LR-N15-0050
April 9, 2015

Salem Nuclear Generating Station, Units 1 and 2
Renewed Facility Operating License Nos. DPR-70 and DPR-75
NRC Docket Nos. 50-272 and 50-311

Hope Creek Generating Station
Renewed Facility Operating License No. NPF-57
NRC Docket No. 50-354

Subject: Response to Request for Additional Information Regarding License Amendment Request to Update Appendix B to Renewed Facility Operating Licenses (TAC Nos. MF5389, MF5390, and MF5391)

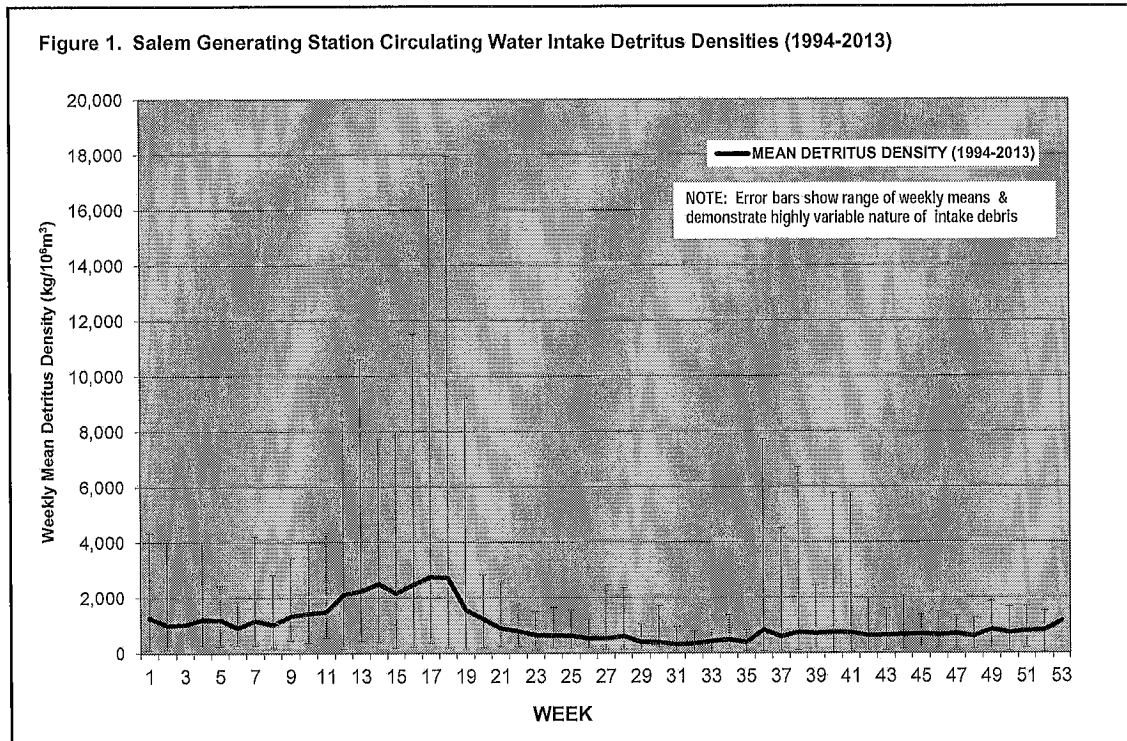
The amount of river debris that will accumulate on the intake trash bars and require raking is highly variable and is difficult to predict. As shown below in Figure 1, the density of river detritus generally remains relatively steady during most of the year and increases during late winter-early spring. Although increased frequency of trash rack raking is required during the peak detritus season, the timing and level of detritus is notoriously difficult to predict, and elevated levels do not even occur during some years with milder weather.

Given the difficulty in predicting seasonal periods when increased trash rack raking may be required, PSEG cannot estimate when more frequent cleaning will be required, but can estimate that cleaning of the intake trash bars will occur at least once per week during all seasons.
